PERMIT MODIFICATION REQUEST
(VOLUME II OF II)
Reconfiguration of Block O

City of Nacogdoches Landfill
Nacogdoches, Texas
TCEQ Permit No. MSW-720

File No. 16209006.26 | January 2024

Attachment No. 6
Redline/Strikeout Pages

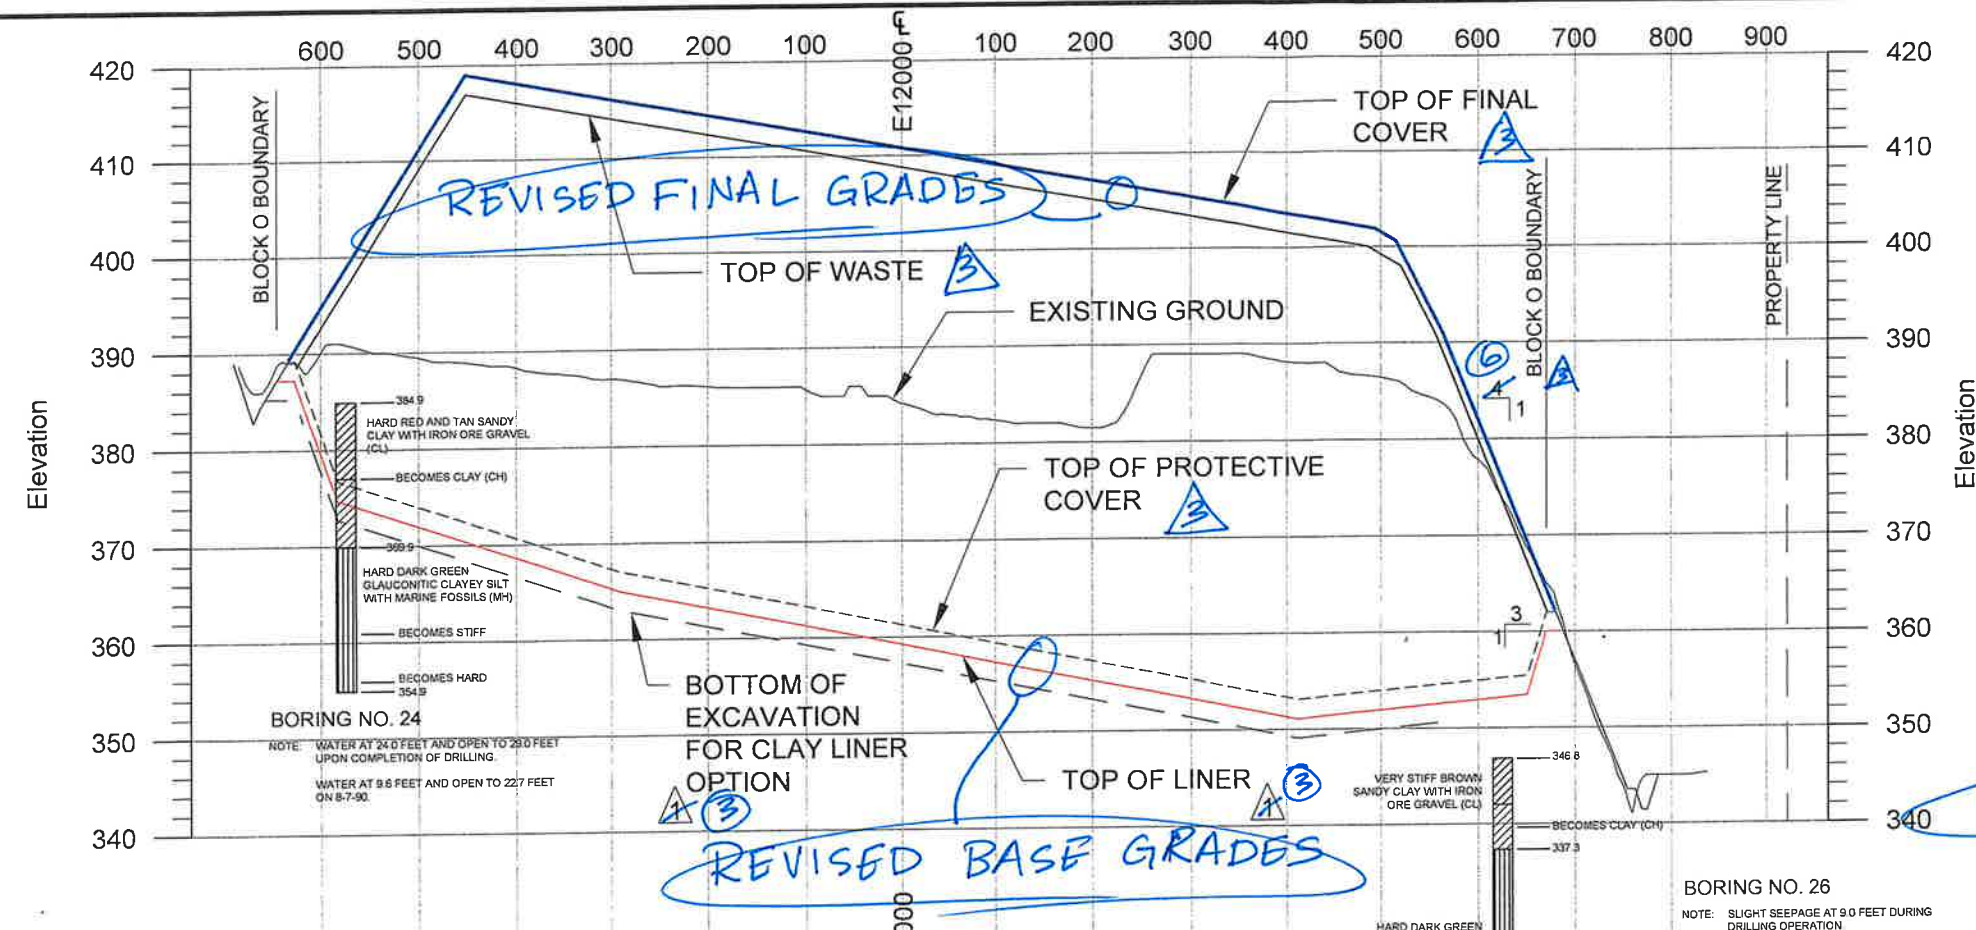
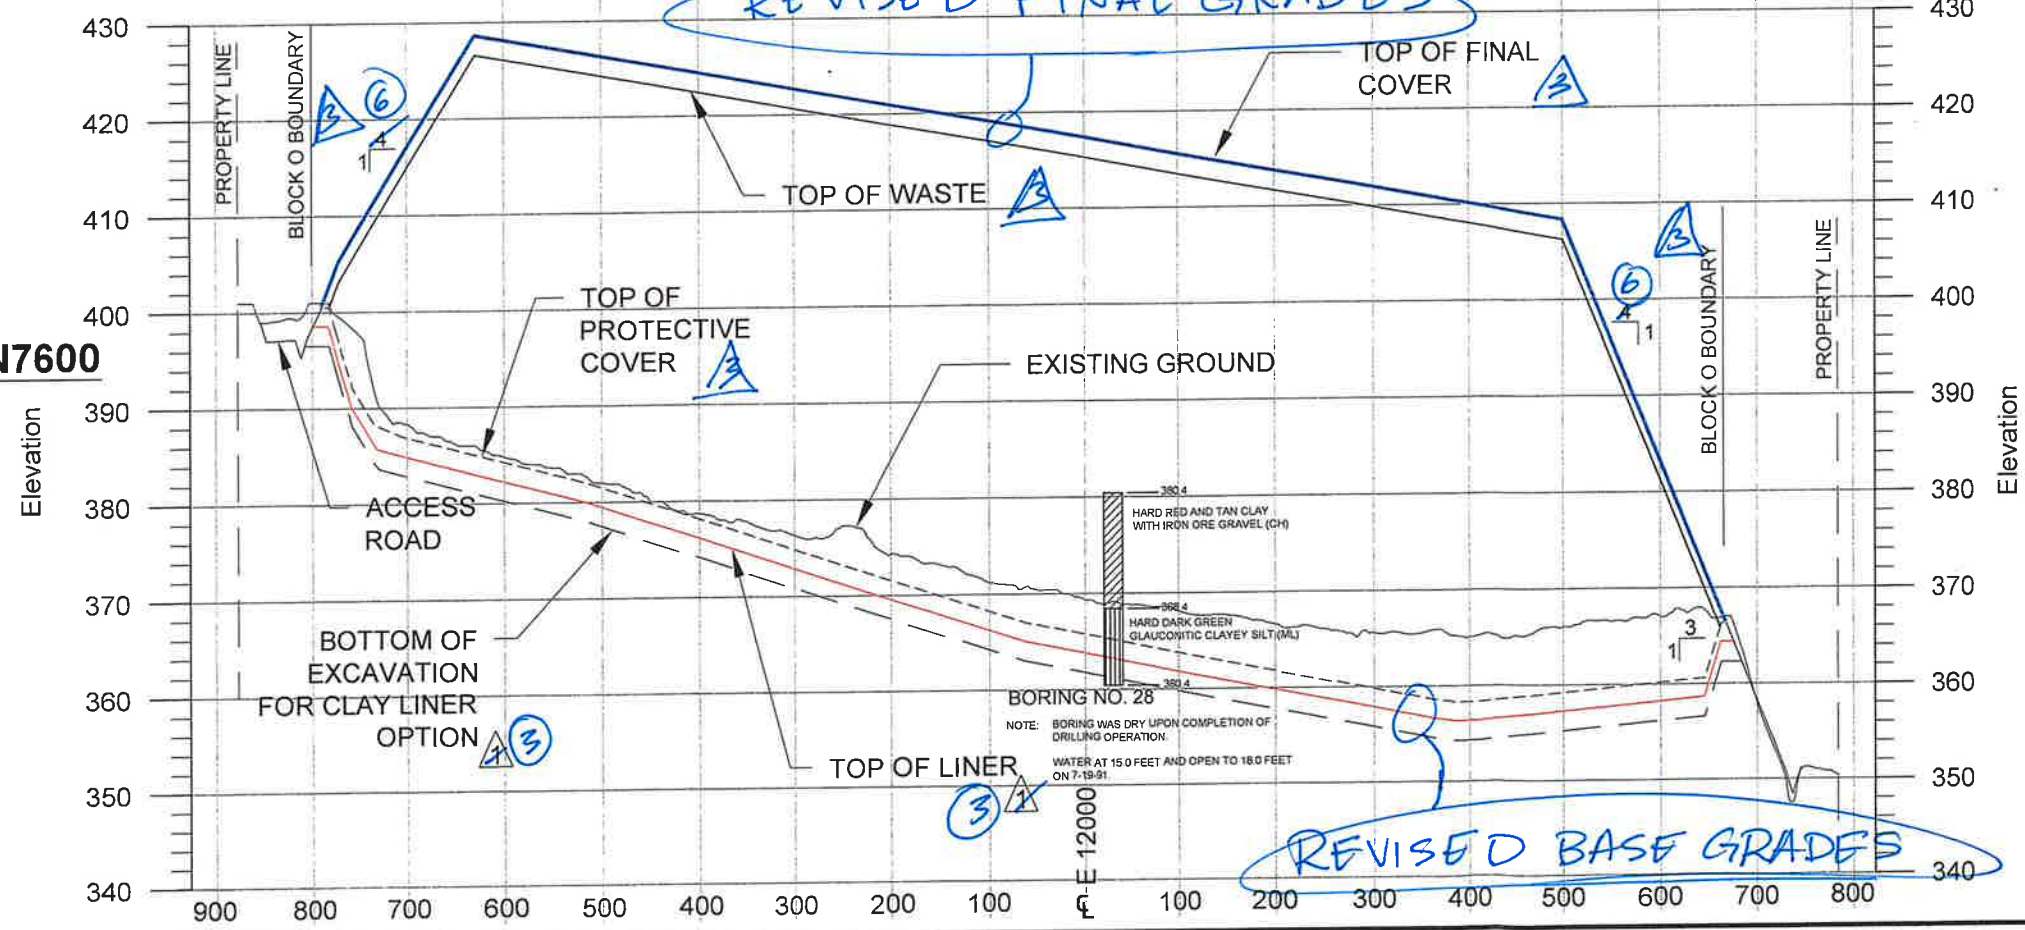
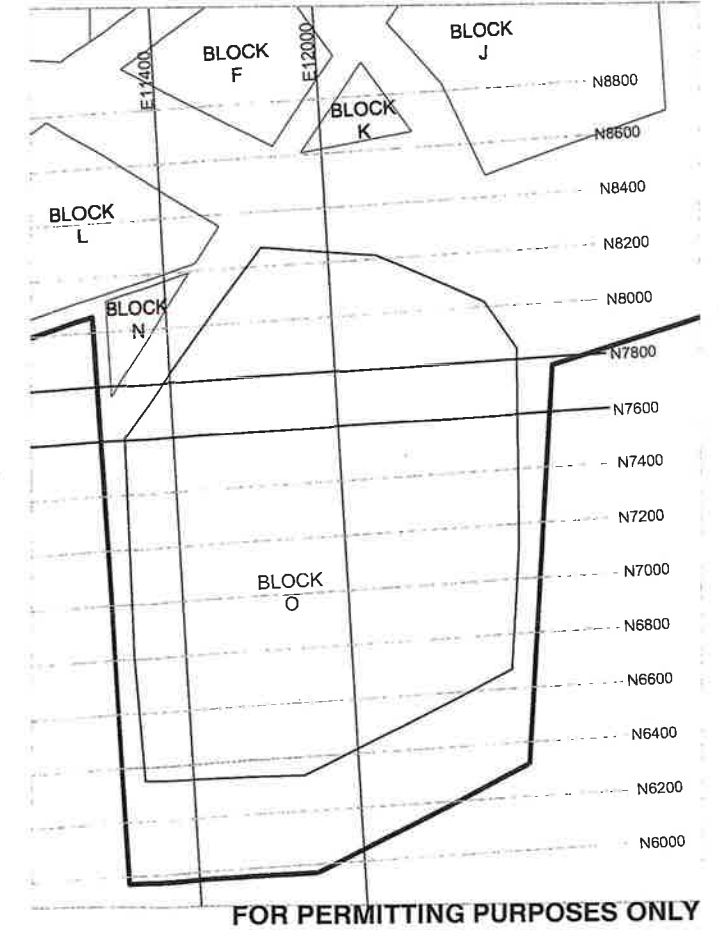
12/2023 REVISE
BASE AND FINAL GRADES
 scs

DRAWING TITLE	III.11.1 ATTACHMENT 6 - GROUNDWATER & SURFACE WATER PROTECTION & DRAINAGE PLAN
PROJECT TITLE	LANDFILL RECONFIGURATION PERMIT MODIFICATION
CLIENT	CITY OF NACOGDOCHES LANDFILL PERMIT NO. MSW-720 NACOGDOCHES, NACOGDOCHES COUNTY, TEXAS
DATE	8/2019
SCALE	AS SHOWN
DRAWING NO.	6B

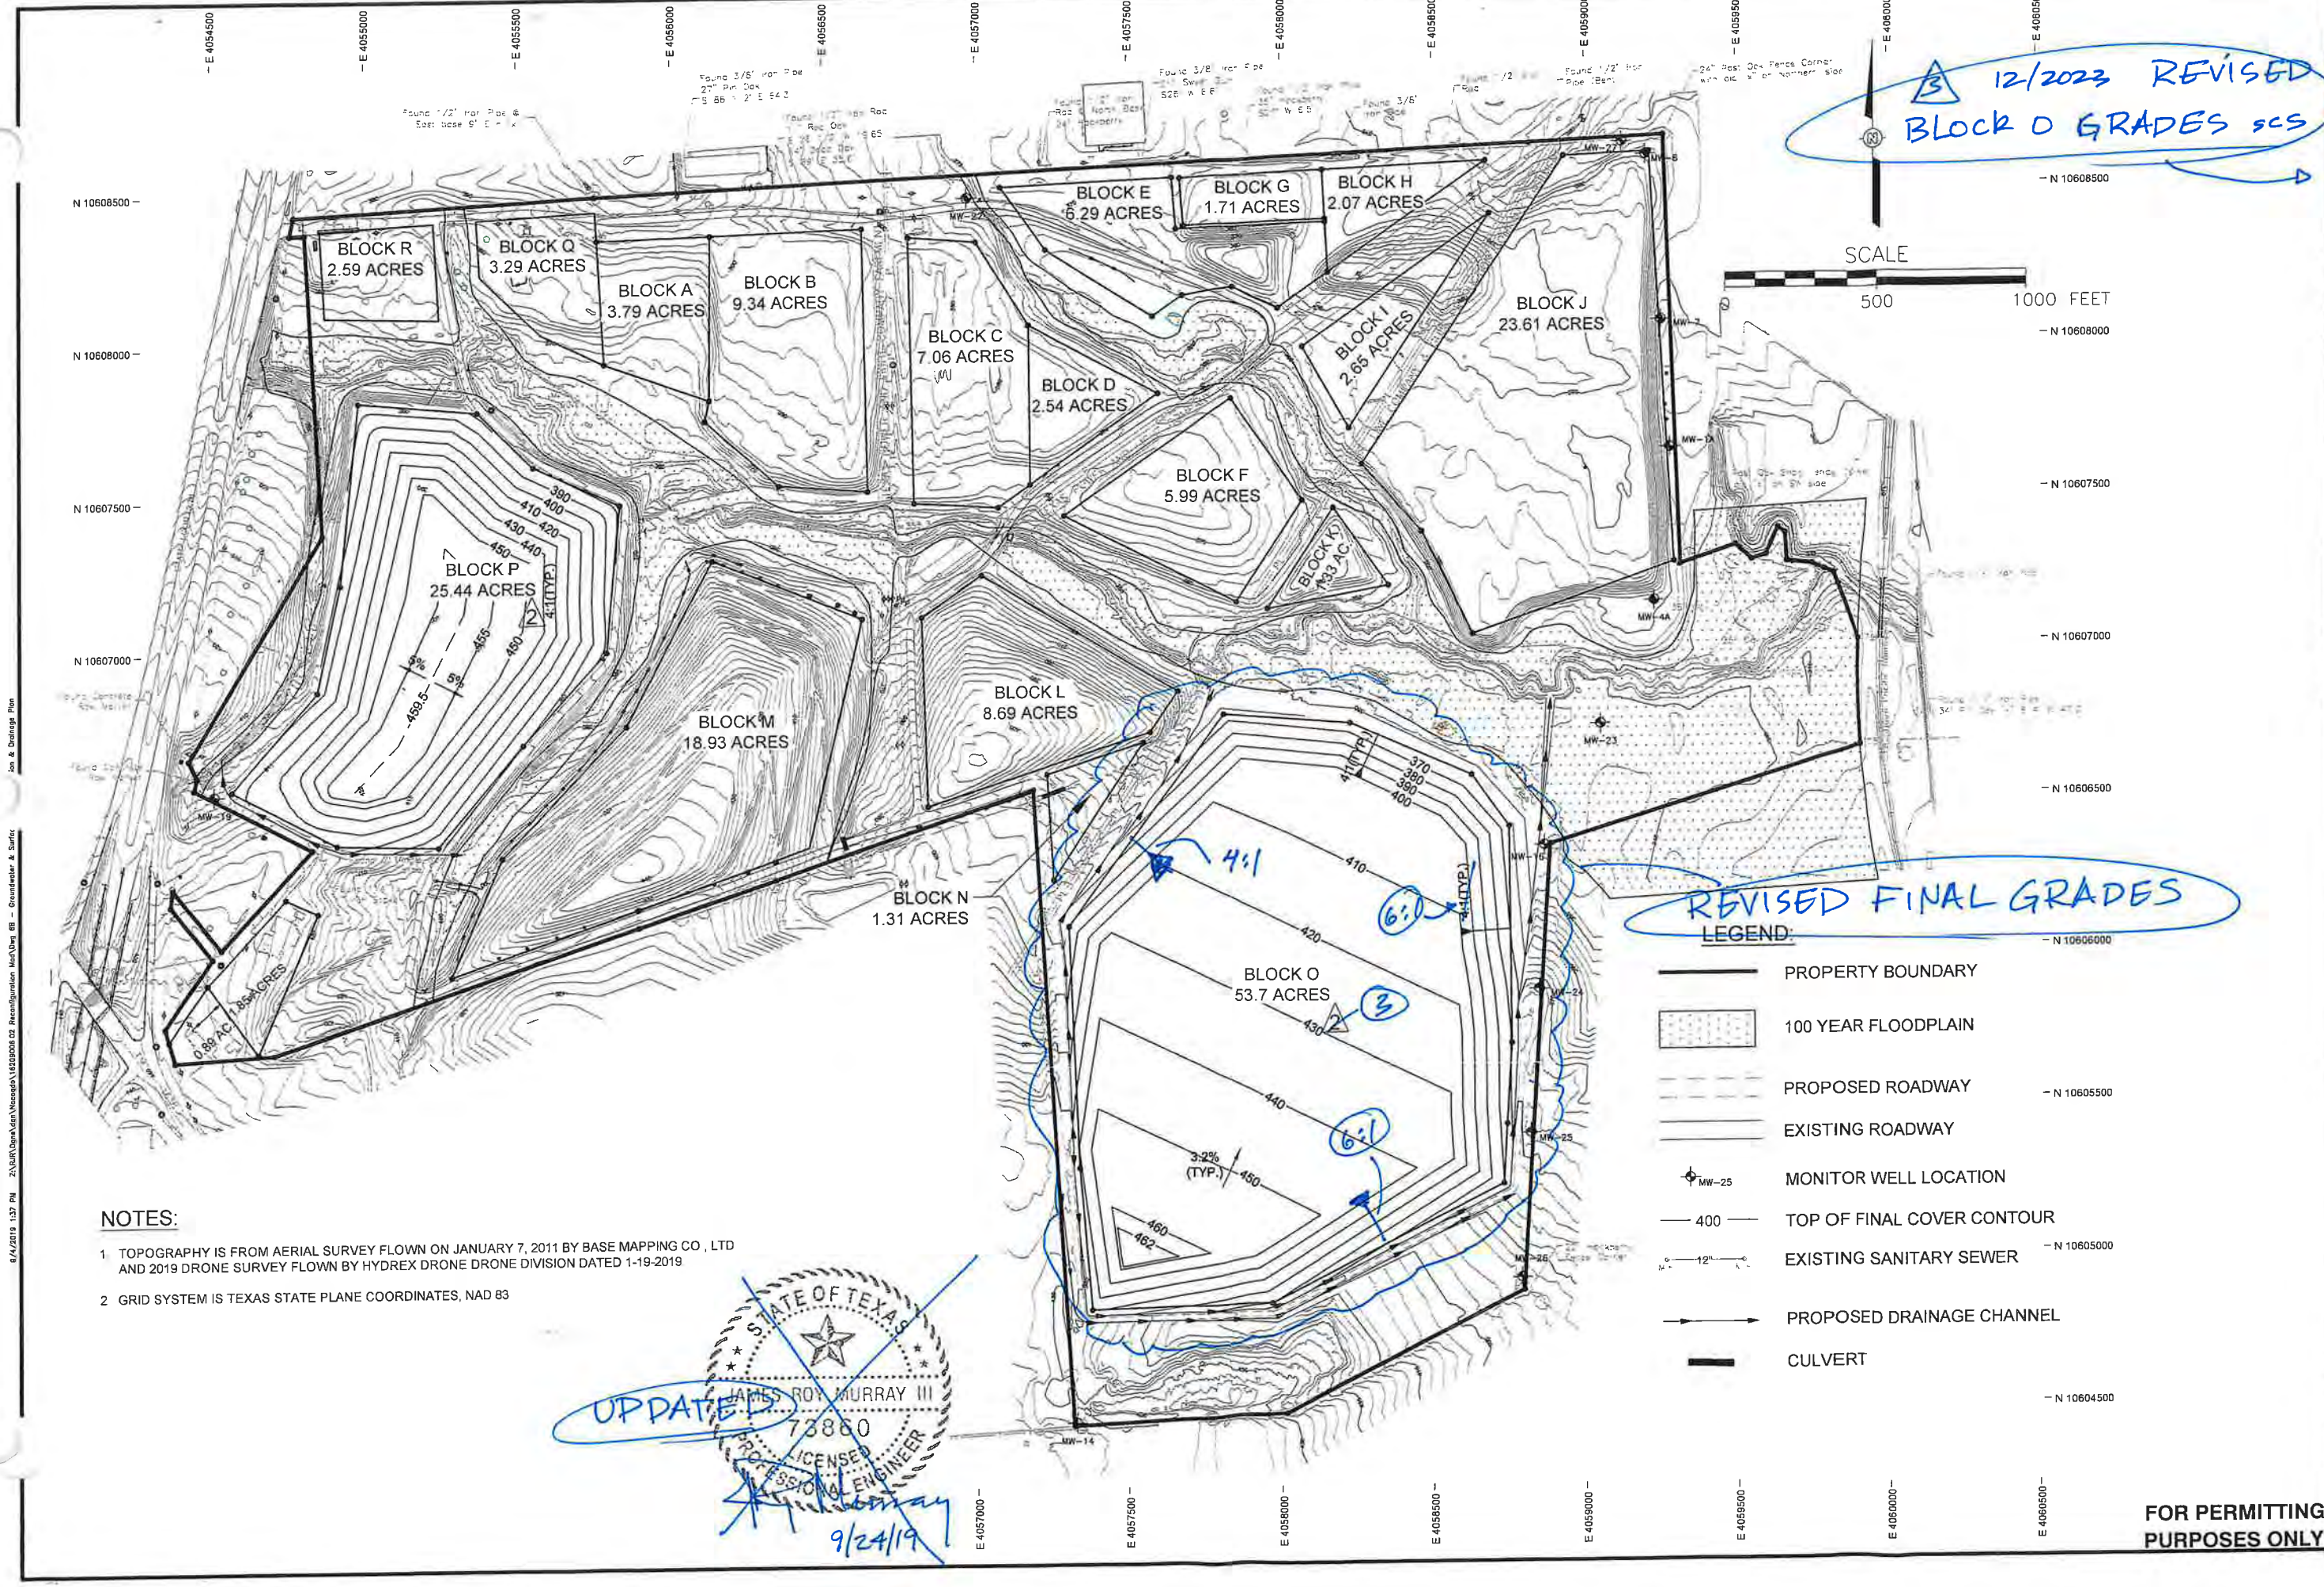
12/2023 REVISED
BLOCK O GRADES scs
